Reg. Ref. *9/A/1616*

PROPOSAL *2 Storey Warehouse unit*

LOCATION *unit 10 Greenhills Rd. D12*

## Record of Executive Business and Manager's Orders

SITE LAYOUT PLAN scale 1/32 : 1'0"

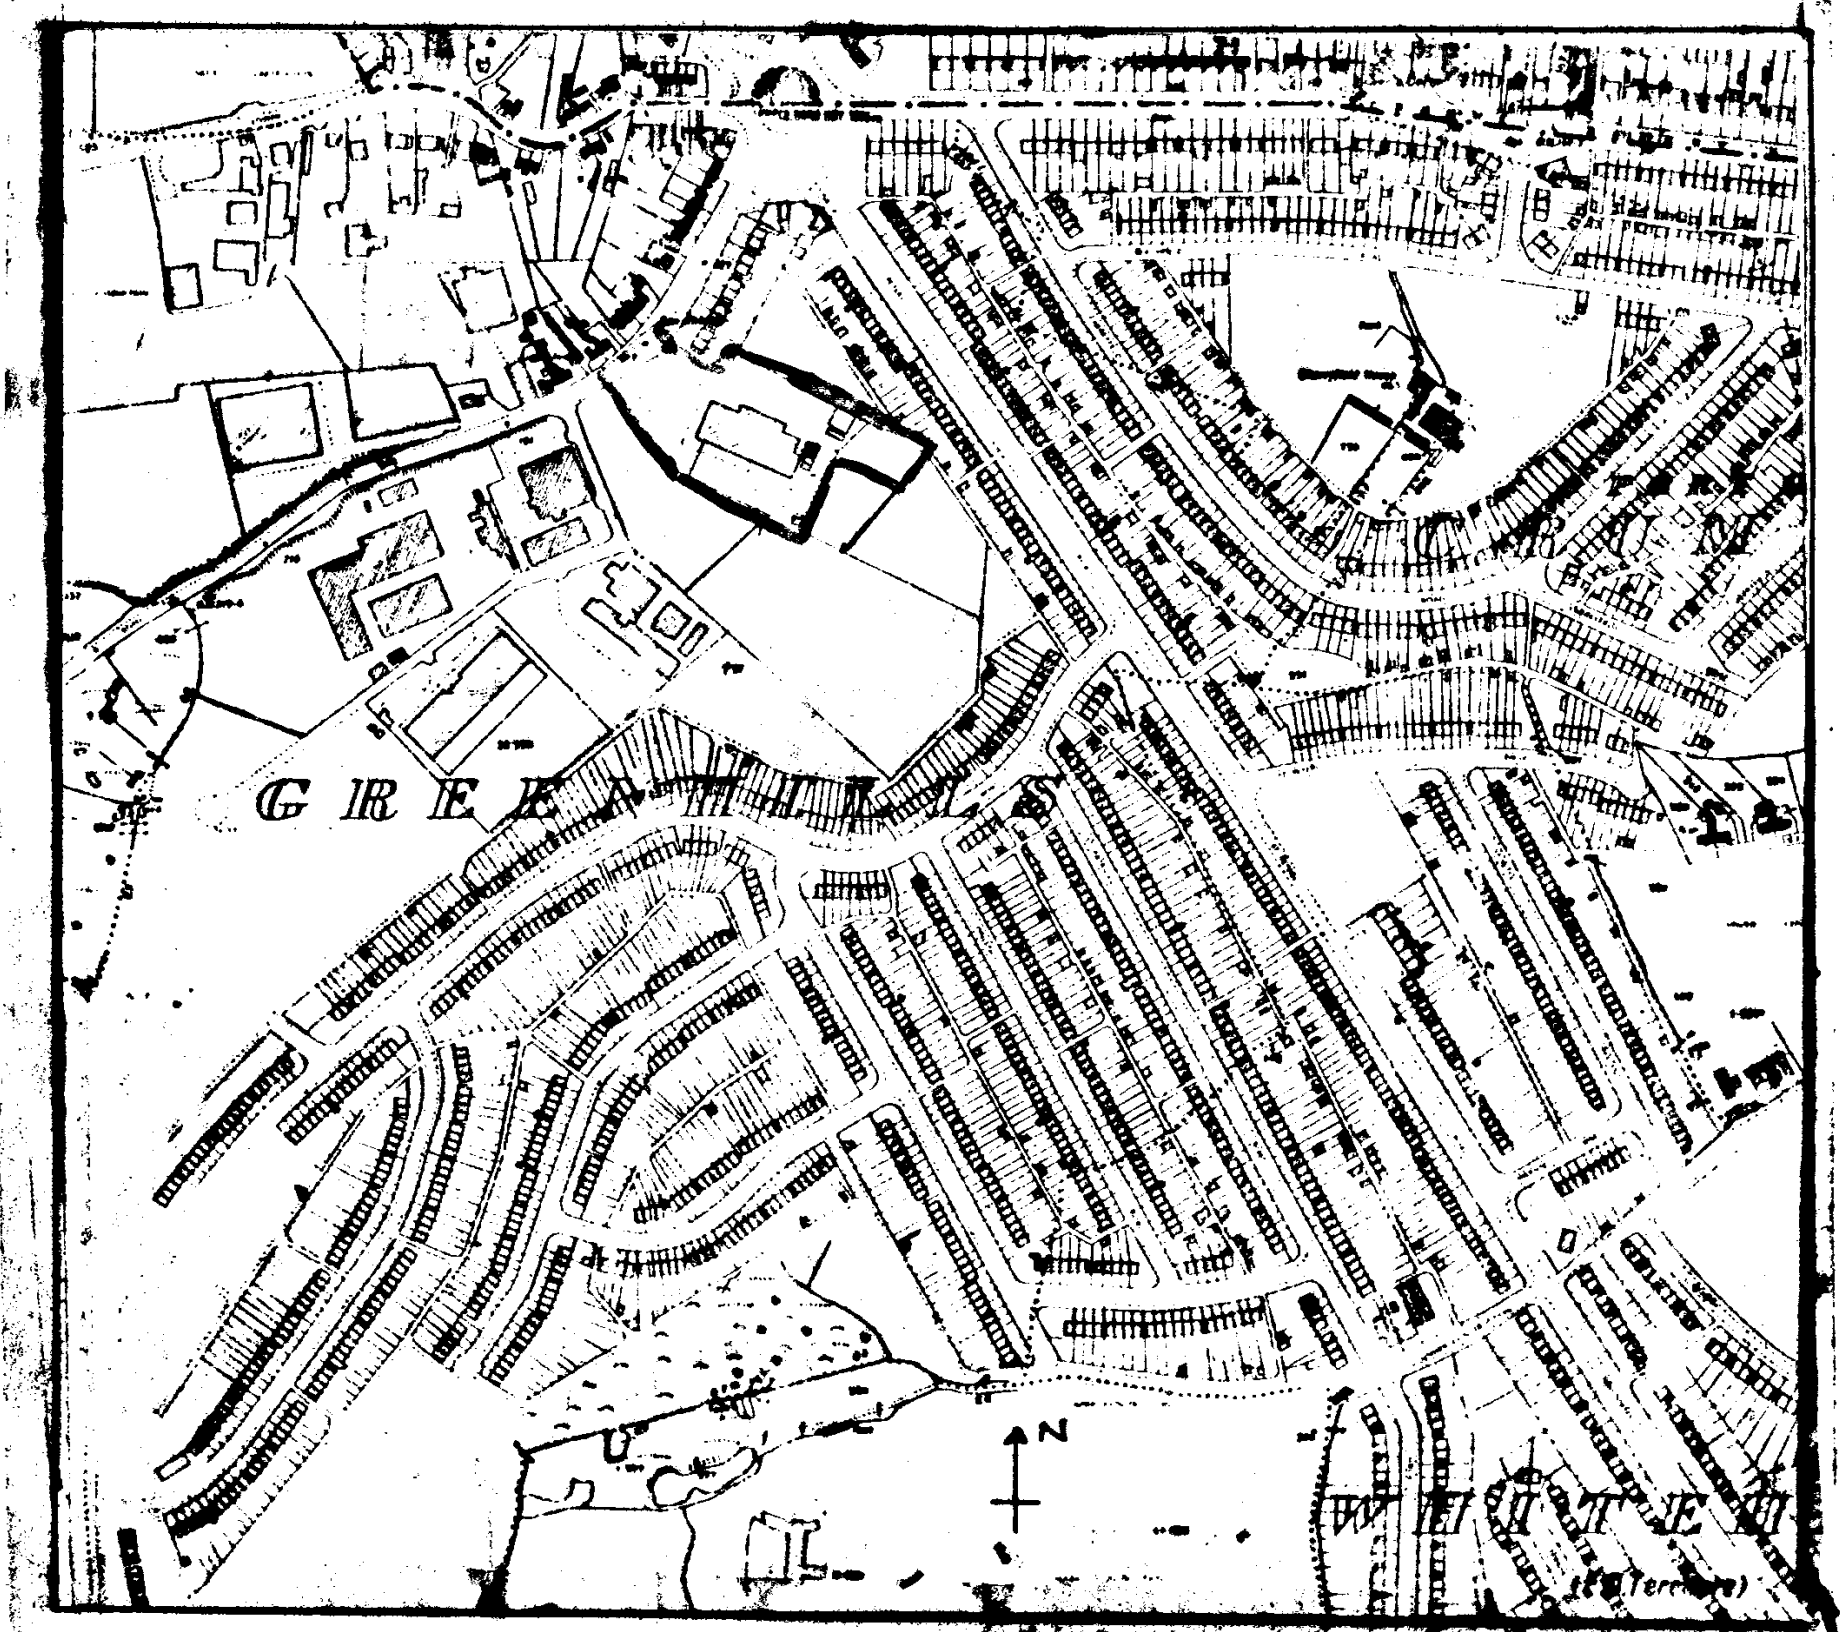
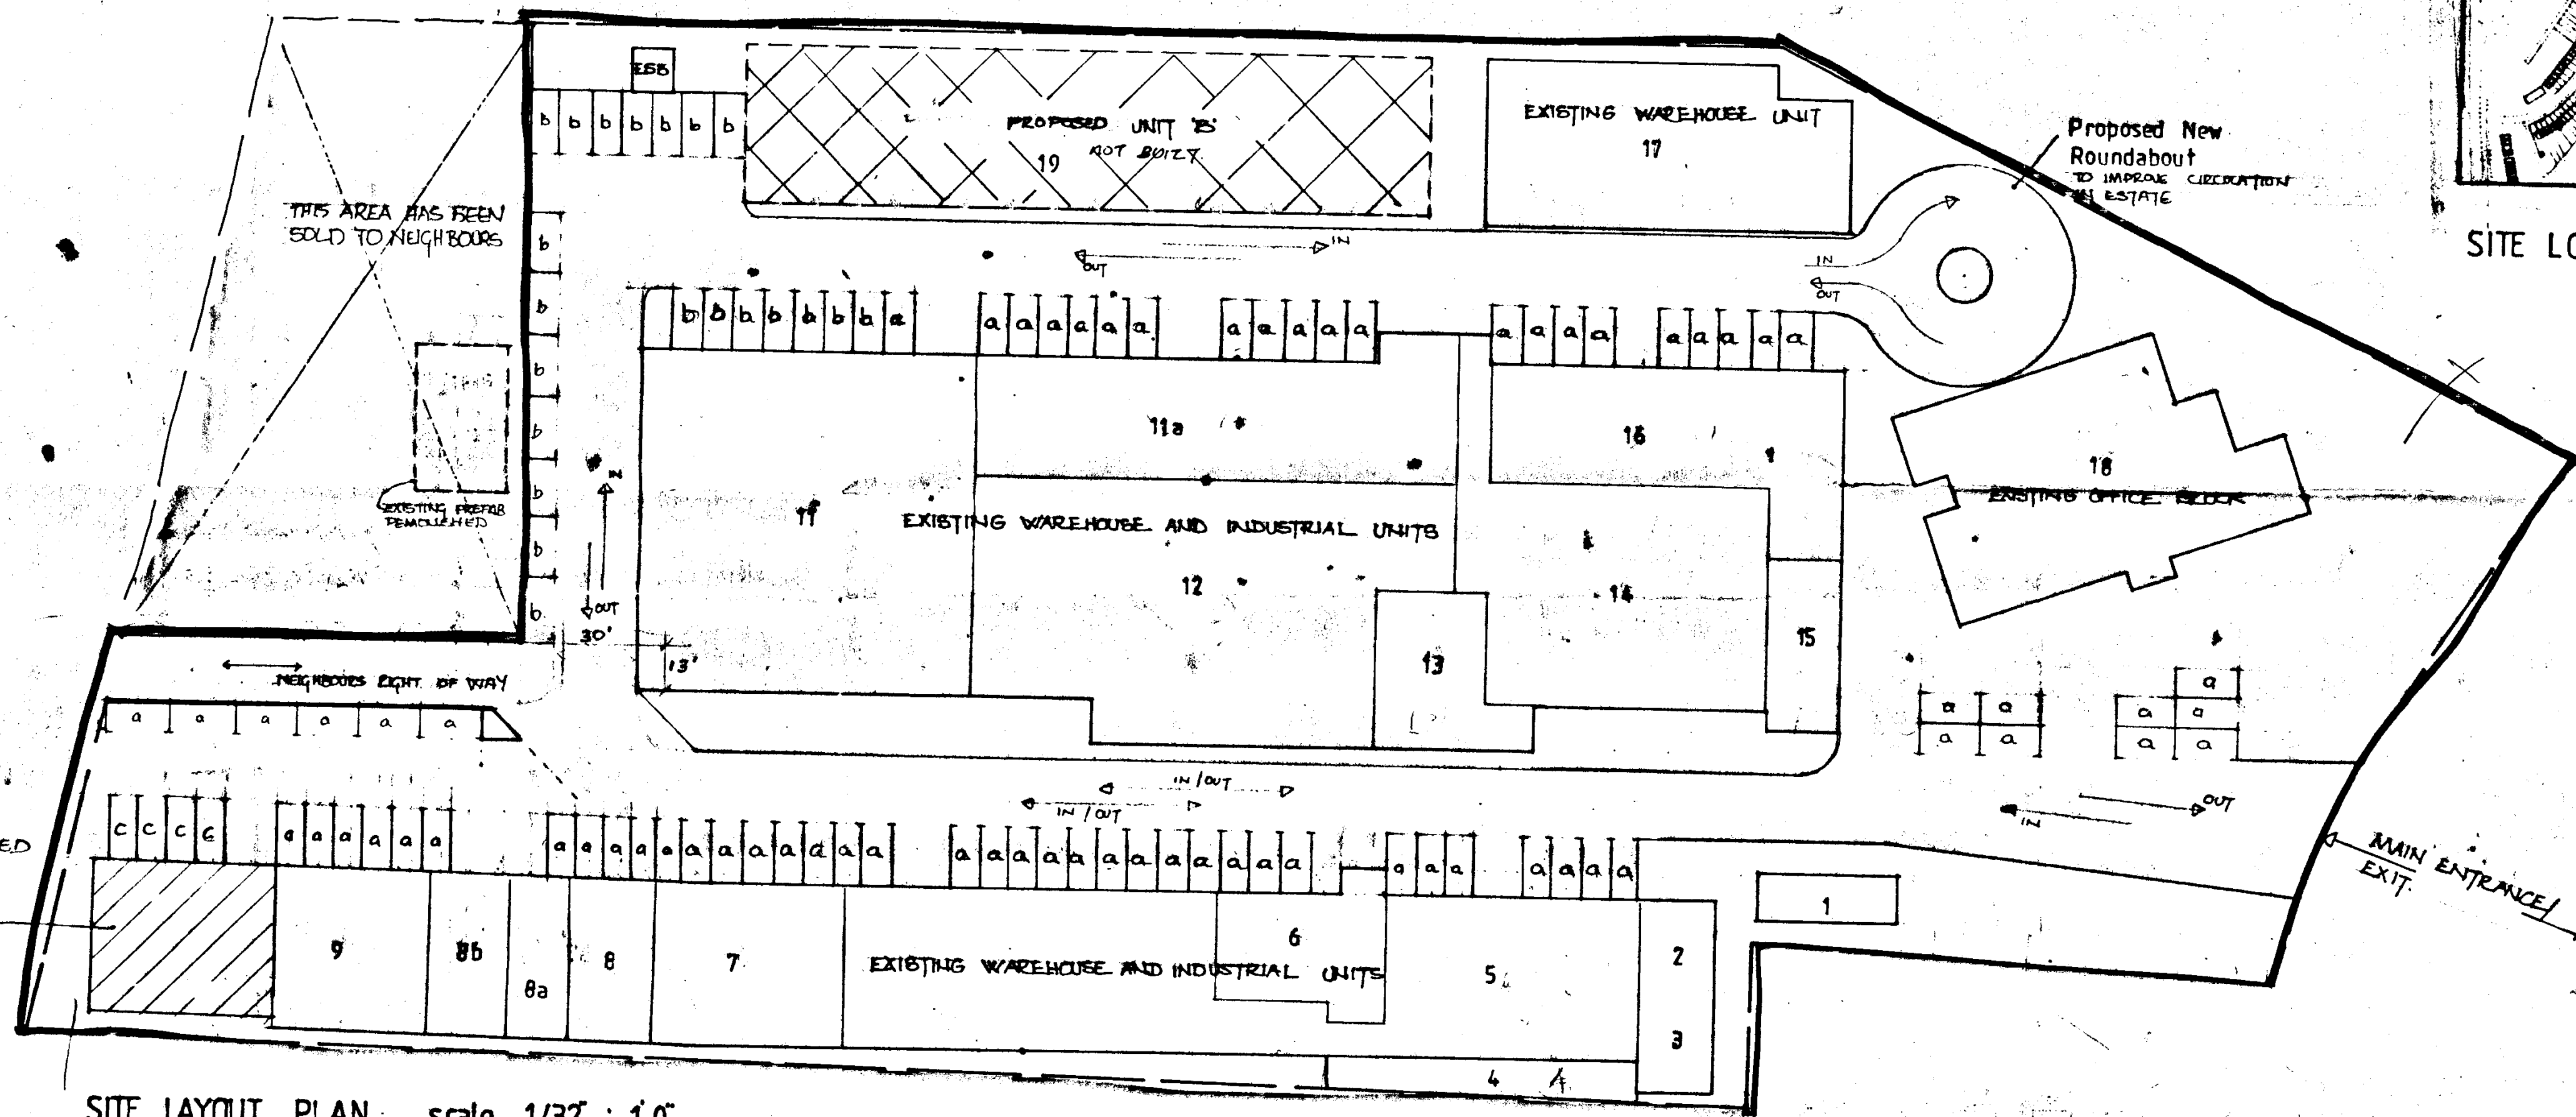
1. The public notice submitted with this application refers to permission sought for warehouse unit No. 10. The site layout plan submitted indicated proposed unit 10 adjoining unit 9 but the title of the plan refers to proposed unit 20. A proposed unit 20 is, however, not indicated on the submitted plans. The ground floor plans as per drawing no. D/17/90 also entitled "proposed unit 20" indicates that the proposed unit adjoins unit 8. The applicant is requested to submit revised plans to clarify what is proposed and to indicate the proposal in relation to existing adjoining development.

Roads Department report recommends refusal as the off street car parking proposed to serve the development is only 4 while the development plan standard would require 10. The space indicated as available for parking to serve the existing development is however not all available for car parking as a result of external storage associated with the development. If all the spaces indicated were available for car parking a shortfall of 5 spaces in the current application would be less significant. I spoke to G. Curran of the Roads Department who indicated a willingness to accept a requirement that all spaces on site be clearly marked out on site and available for car parking at all times. A financial contribution of f 2000

As stated in our Roads report dated 28.10.91 the car parking proposed on the lodged drawing on that occasion was satisfactory to the Roads Department. However, the applicant has now revised the car parking layout to allow right of way to a neighbours site. This has reduced the number of car spaces by 7 and the net car spaces available for the proposed development of 380 sq. metres is 4 spaces. The Roads Department as previously stated requires that any further development in this estate should have parking to Development Plan Standards. The present provision is not satisfactory.

1. The provision of off-street parking to serve the proposed development is very substandard with regard to Development Plan requirements. This would lead to on street parking on the Greenhills road which is a busy distributor route and thereby endanger public safety by reason of traffic hazard.

3. The applicant has submitted a revised site layout plan indicating car parking spaces as follows:-

73 spaces to serve the existing development

21 spaces to serve the development previously approved under Reg. Ref. 89A/1990

4 spaces to serve the proposed unit 10.

- 07 That the car parking spaces indicated on the layout plan drawing no. D/17/90 Z received as additional information on 3rd February, 1992, shall be clearly marked out on the site in respect of the existing and proposed developments, and such markings shall be maintained in good condition and these car parking spaces shall be available at all time for parking. Suitable signs to be agreed shall be erected at appropriate locations at this entrance and within the site indicating the availability of car parking spaces.

3. We have included four copies of our Site Layout Plan indicating the layout of carparking spaces.

SITE LAYOUT PLAN scale 1/32 : 1'0"

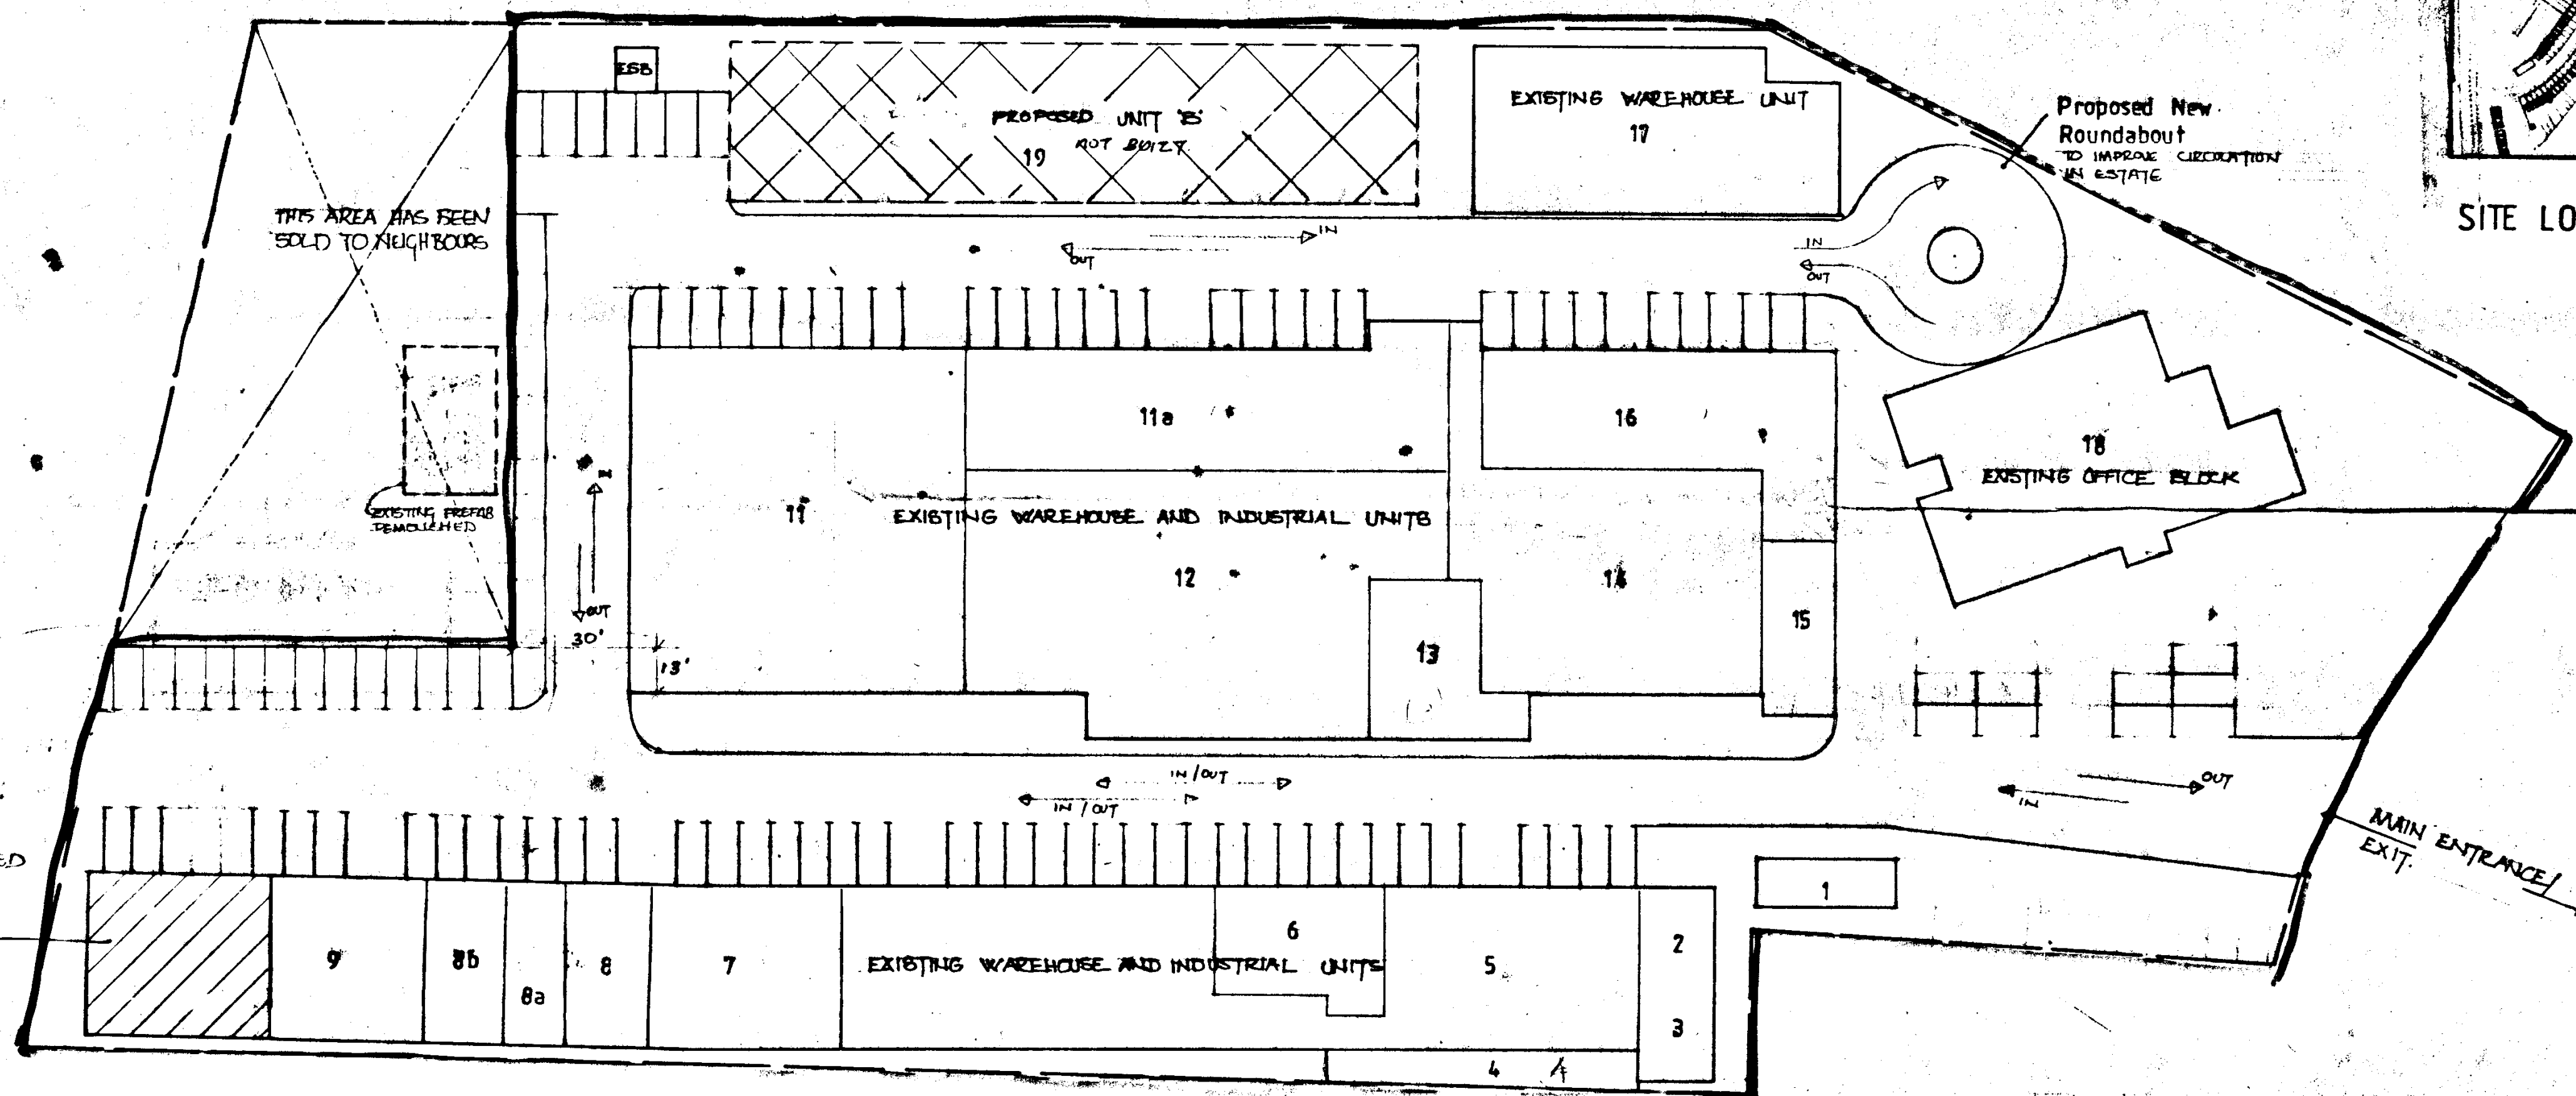
01 The public notice submitted with this application refers to permission sought for warehouse unit 10. The site layout plan submitted indicates proposed unit 10 adjoining unit 9 but the title of the plan refers to proposed unit 20. A proposed unit 20 is, however, not indicated on the submitted plans. The ground floor plans as per drawing No. D/17/90 also entitled "proposed new unit 20" indicates that the proposed unit adjoins unit 8. The applicant is requested to submit revised plans to clarify what is proposed and to indicate the proposal in relation to existing adjoining development.

03 The applicant is requested to submit a site layout plan indicating a layout of car parking which provides for:

- (a) the car parking spaces to serve the existing development;
- (b) the car parking spaces to serve previously approved development. In this regard the applicant is advised that the site of the current application was indicated on plans approved for an industrial unit under Reg. Ref. 89A-1990 as a car parking area to serve the development;
- (c) the car parking spaces required to serve the proposed development.
